GOVERNMENT OF THE DISTRICT OF COLUMBIA  
DEPARTMENT OF TRANSPORTATION

**MEMORANDUM**

**SUBJECT:** ZC Case No. 11-03J – The Wharf Phase 2

Figure 2 – Loading Access (Source: CTR, Gorove/Slade, Figure 26, 9/18/17)

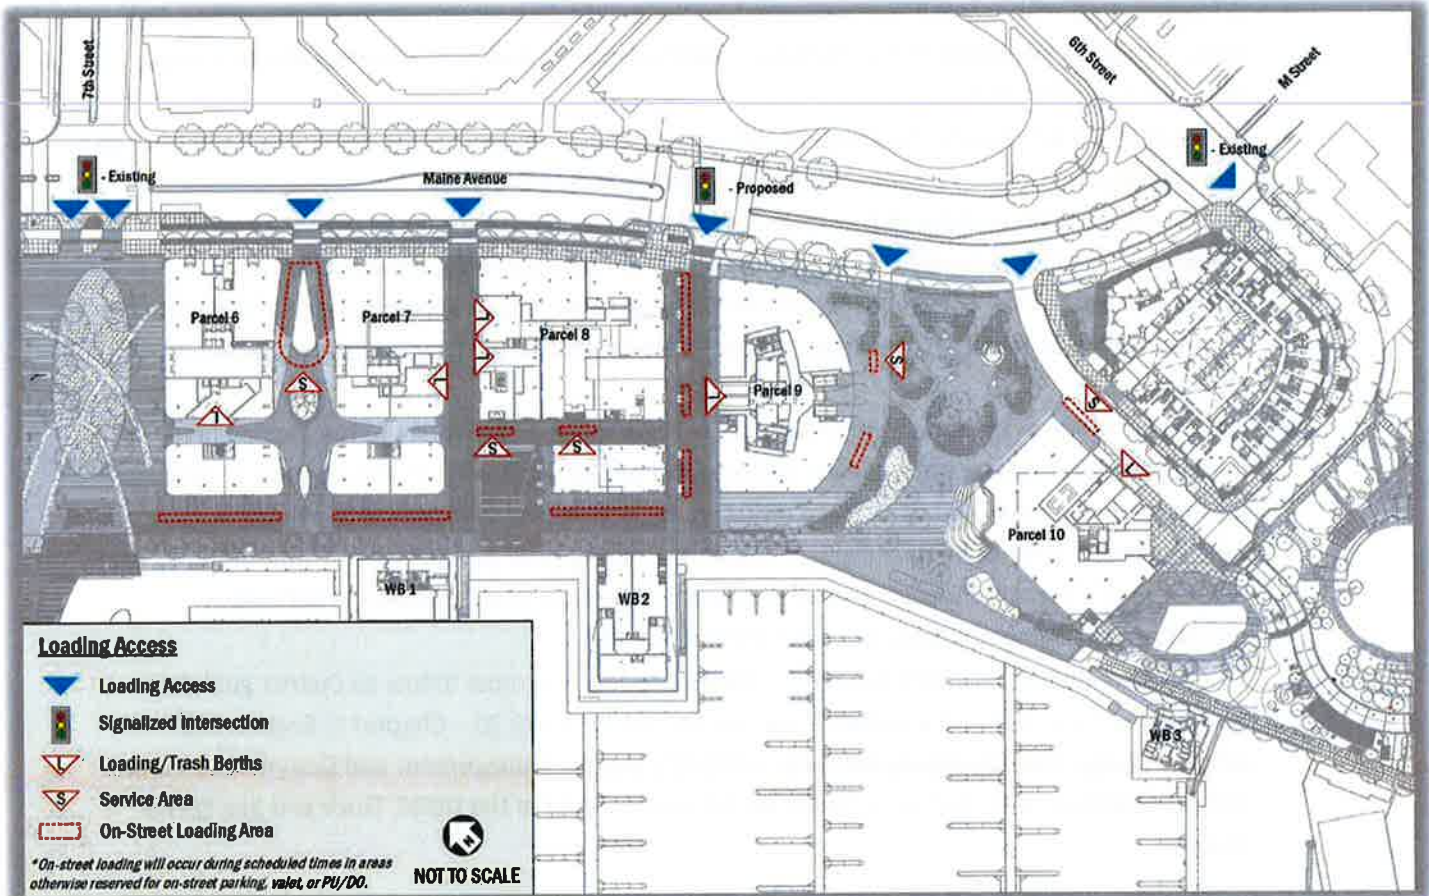
DDOT finds the Applicant's proposed loading scheme (shown in Figure 2 below) and requested loading relief to be acceptable on the condition that the Loading Management Plan be implemented, as proposed in the CTR. DDOT also clarifies that the Applicant's proposed "on-street" delivery/loading areas will be on private streets internal to the property and will not impact the public space.

Figure 9 – Future Pedestrian Facilities (Source: CTR, Grove/Slade, Figure 72, 9/18/17)

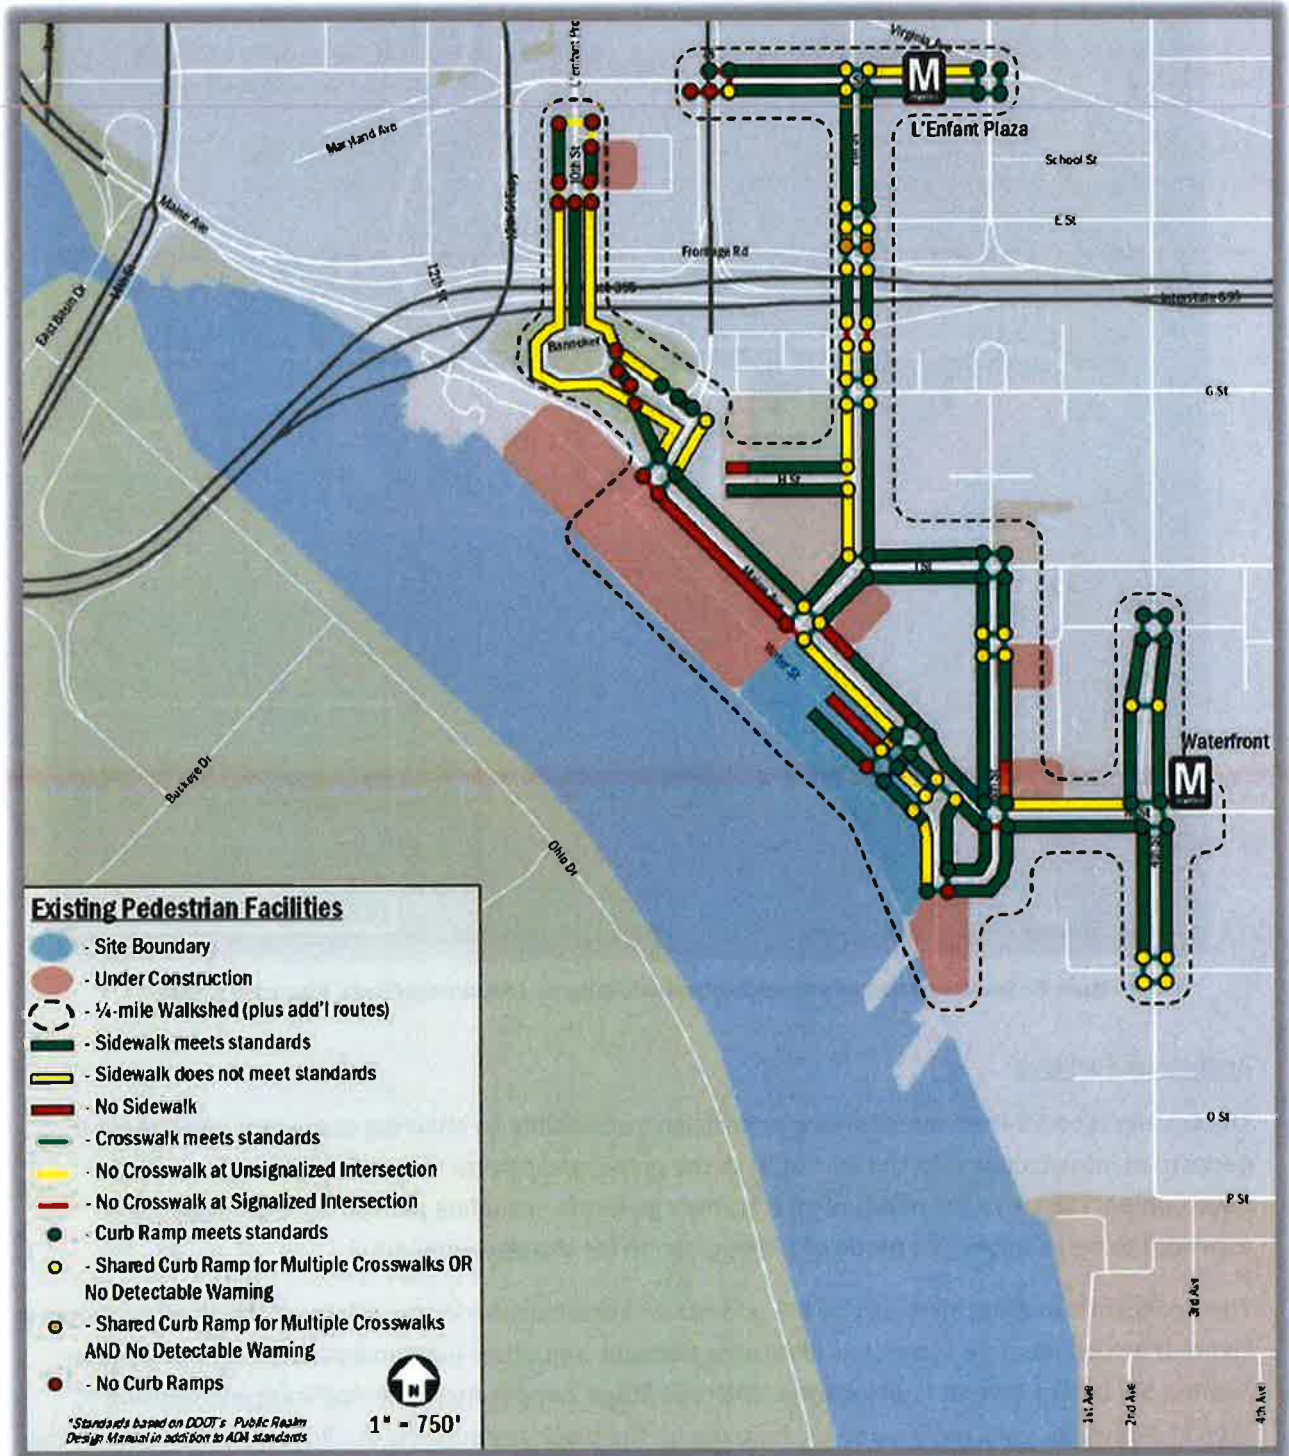
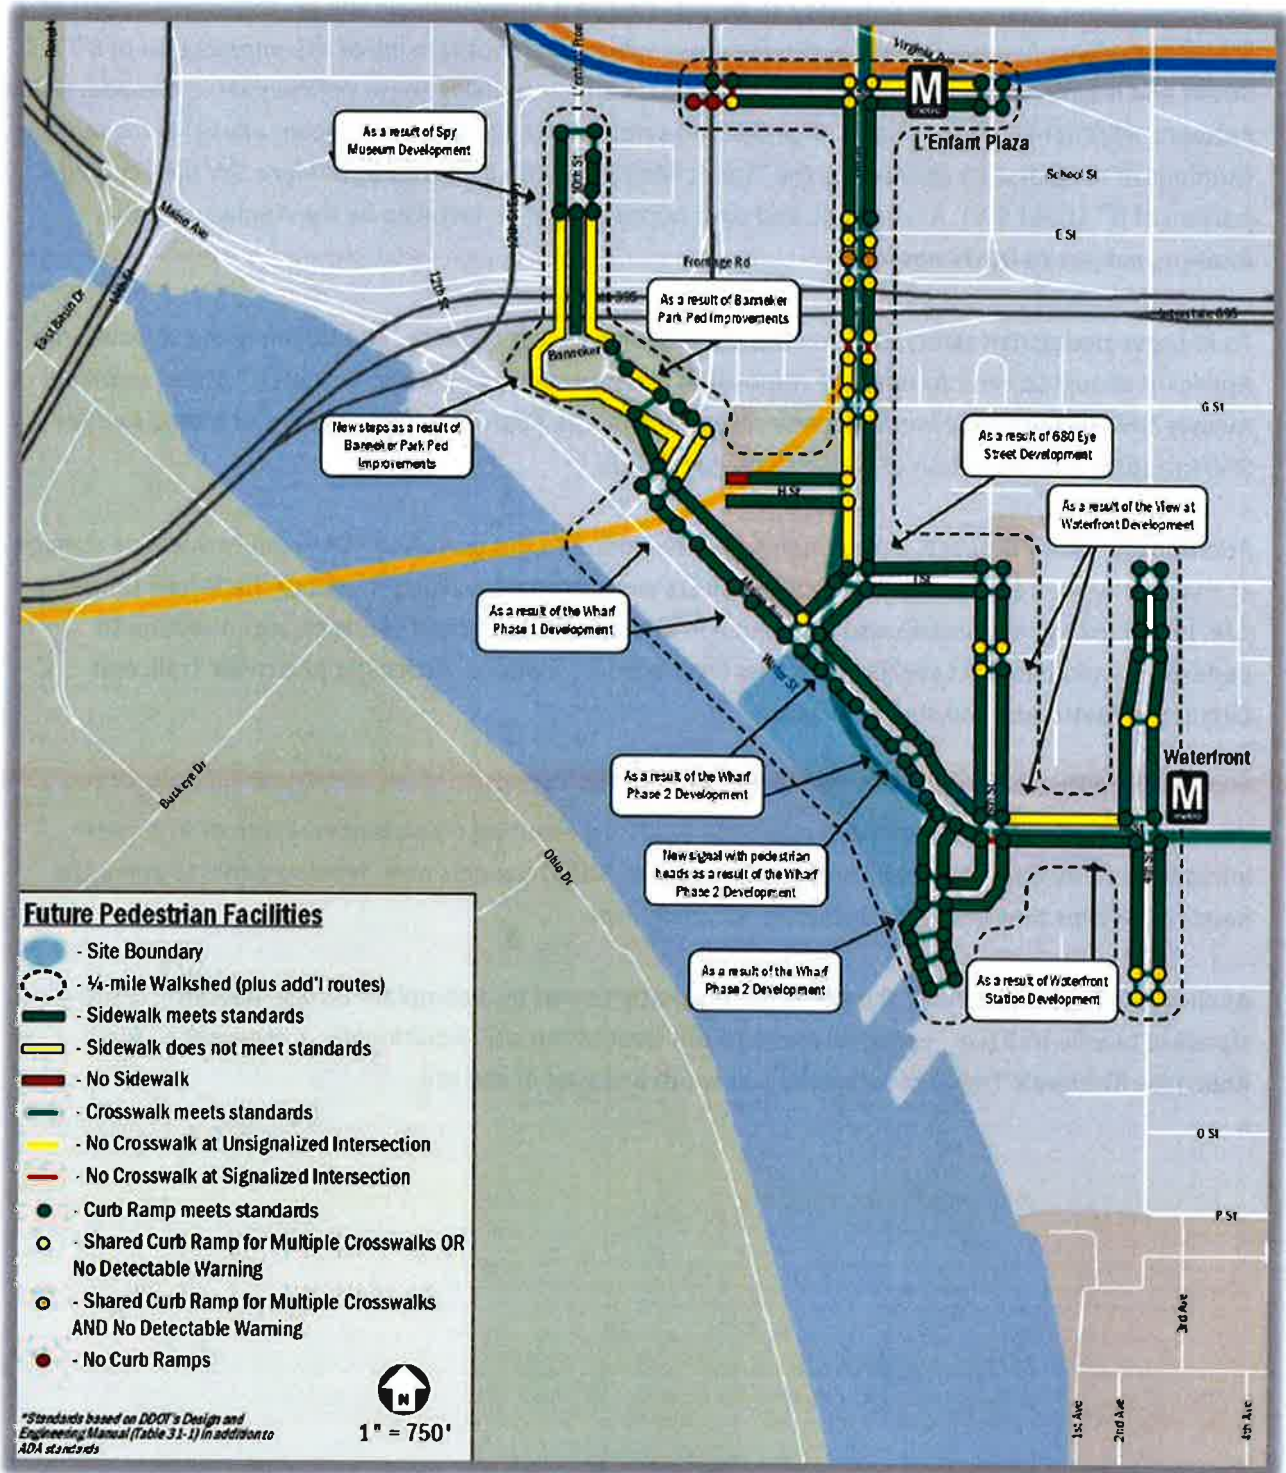
As shown above, there is still projected to be sub-standard curb ramps on the northwestern corner of 7<sup>th</sup> Street and Maine Avenue SW and a missing crosswalk on the southern leg of the intersection of 6<sup>th</sup> Street and Maine Avenue SW. The Applicant should commit to fixing these deficiencies in the pedestrian network. Another location in need of pedestrian safety improvements (not shown above) is the current terminus of the sidewalk connecting the Titanic Memorial with Parcel 11 at M Place SW (i.e., curved portion of 6<sup>th</sup> Street SW). A crosswalk and curb ramps should be installed by the Applicant at this location, subject to DDOT approval.

To improve pedestrian safety, shorten the pedestrian crossing distance, and slow moving vehicles, the Applicant should commit to fund the removal of the southbound right slip lane on 6<sup>th</sup> Street at Maine Avenue SW (similar to the work recently completed by the Applicant at 9<sup>th</sup> Street and Maine Avenue SW) including any relocation of traffic signal hardware.

Figure 10 – Existing Bicycle Infrastructure (Source: CTR, Gorove/Slade, Figure 73, 9/18/17)

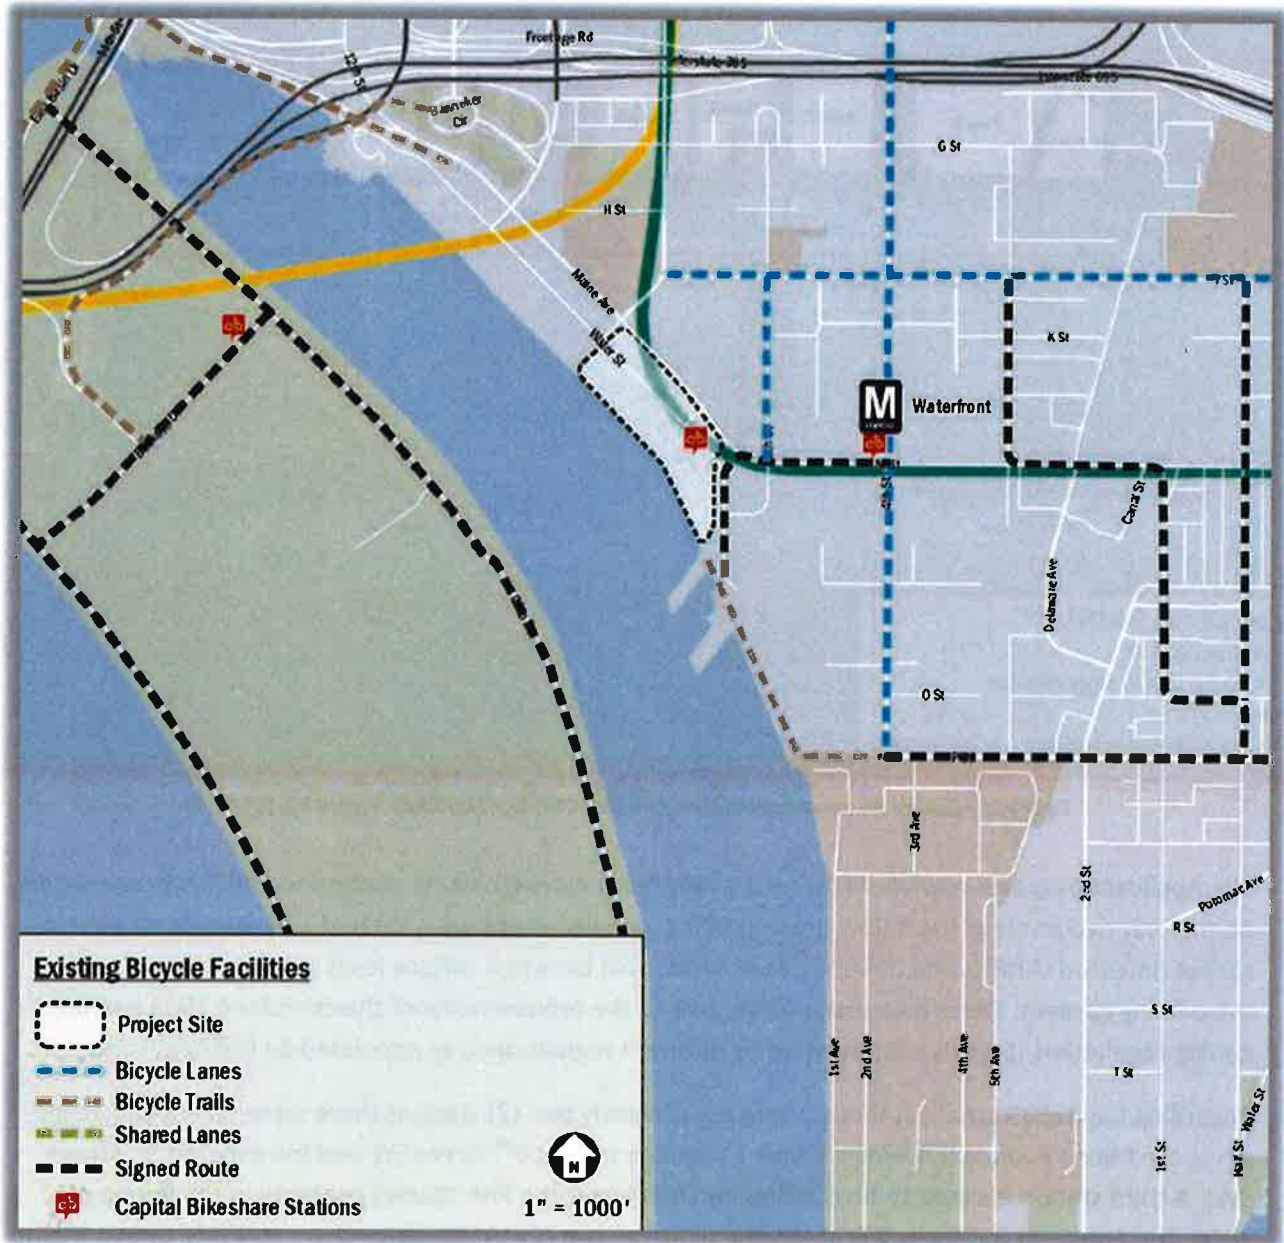
As shown in Figure 10 below, the site is not currently served by a complete bicycle network. A sub-standard bicycle trail (i.e., sidewalk) exists to the west of the site. Additionally, a segment of the Anacostia Riverwalk Trail is constructed just south and east of the site.
